Subject: SES Solar Two (08-AFC-5)
Responses to CURE Data Requests 143-178
URS Project No. 27657102.00900

**In Response to CURE Data Requests 143-178
Application for Certification (08-AFC-5)
SES Solar Two, LLC**

Potentially Occurring Rare Plants on the Solar II Site

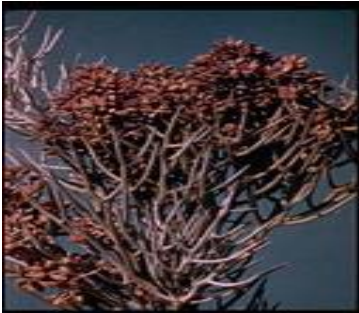
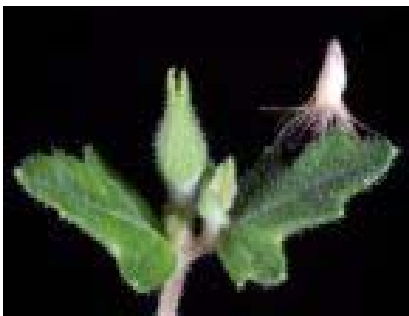
Data Request 149: Please provide a copy of the rare plant guide that was prepared by URS and distributed to the survey team.

Response: The rare plant guide is provided behind this response as attachment BIO-1. Several other reference books were also available in the field to aid with plant species identification.

**BIOLOGICAL EFFECTS
SOLAR TWO PROJECT**

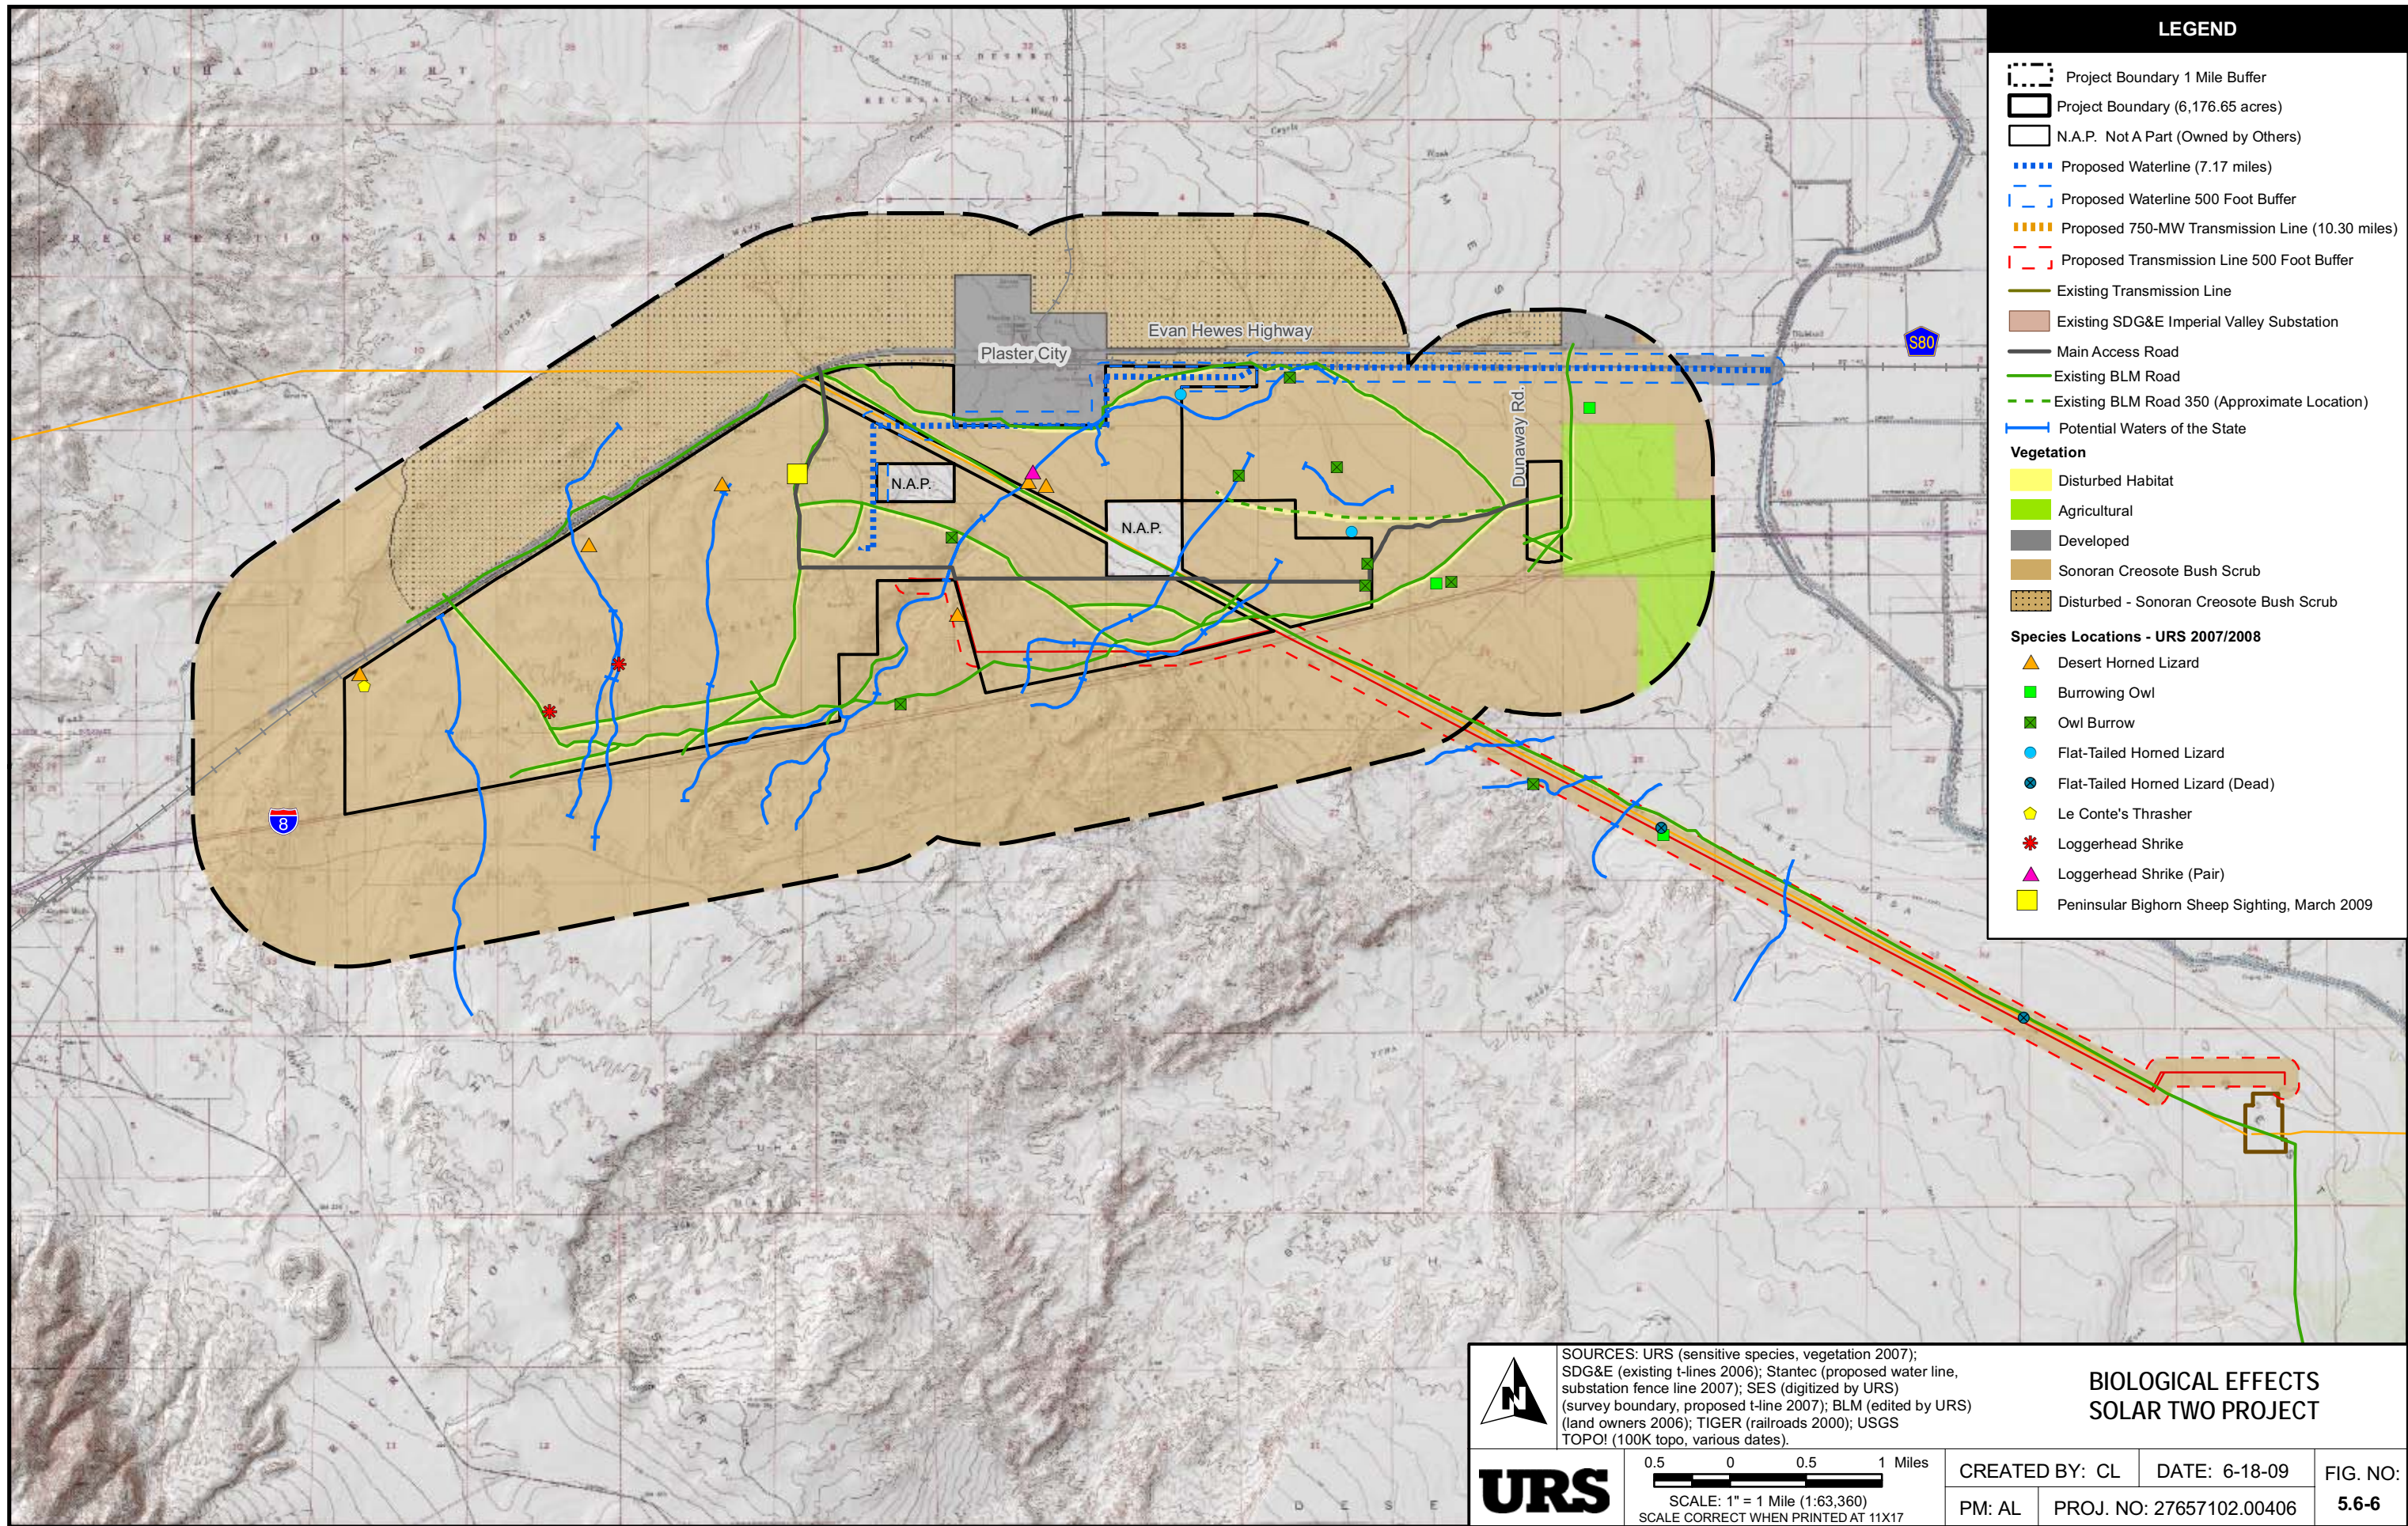
Please provide additional information on bighorn sheep occurrence within the Project area, including:

- a. A map that shows the location of the ewe group that was detected onsite.
- b. Any behavioral (e.g., foraging) observations made by Dr. Platt.
- c. Any subsequent efforts (field or other) taken by the applicant to document bighorn use of the Project site following Dr. Platt's observations.
- d. Quantification of previous efforts devoted to surveying the locations surrounding the area where sheep were recently documented. That is, of the survey days in 2007 and 2008, how many hours were devoted to surveying the area where sheep were documented?

- a. No GPS point of the bighorn sheep observed onsite was taken by Joe Platt, and therefore, only an approximate location based on the description given by Dr. Platt is shown on the attached figure, provided behind this response as attachment BIO-2.
- b. Dr. Platt's observations were provided on DR 44.
- c. No additional surveys for bighorn sheep have been initiated. Despite several subsequent site visits, Dr. Platt did not have any further sitings during his visits to the Solar Two project area.
- d. The entire site was surveyed in both 2007 and 2008. No bighorn sheep or sign of bighorn sheep were observed during the field effort.
